U.S. Department of the Interior BUREAU OF LAND MANAGEMENT Sundry Print Reports
08/30/2021

Type of Submission: Notice of Intent

Type of Action Plug and Abandonment

## Gissler B 28 - NOI to P&A

Wellbore schematics attached

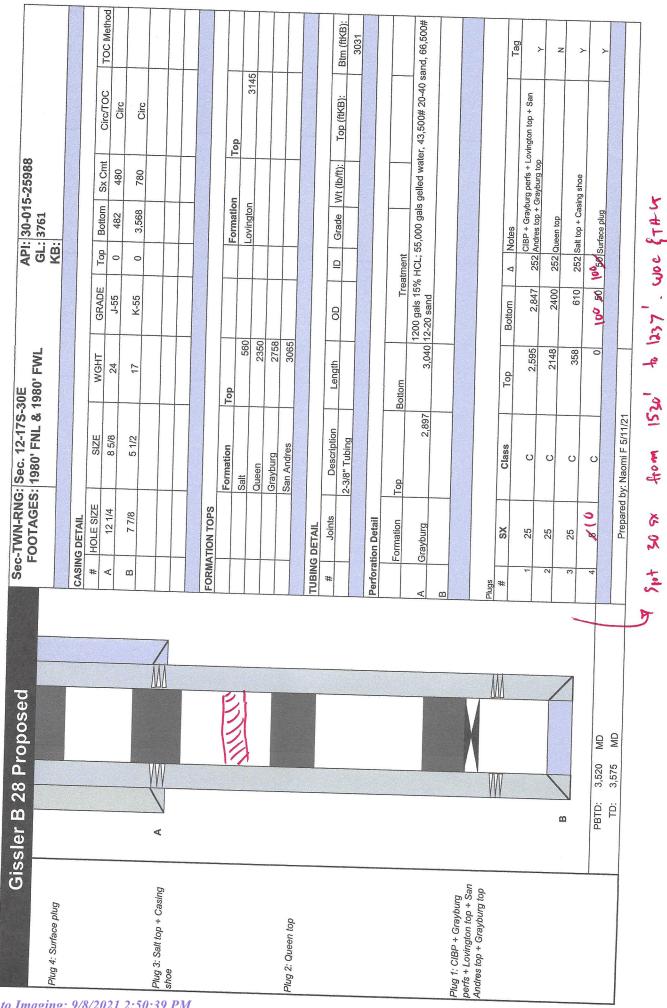
Spot 30 sx from 1530' to 1237'. WECKTAG (B. Salte 1800', Yates@1480')
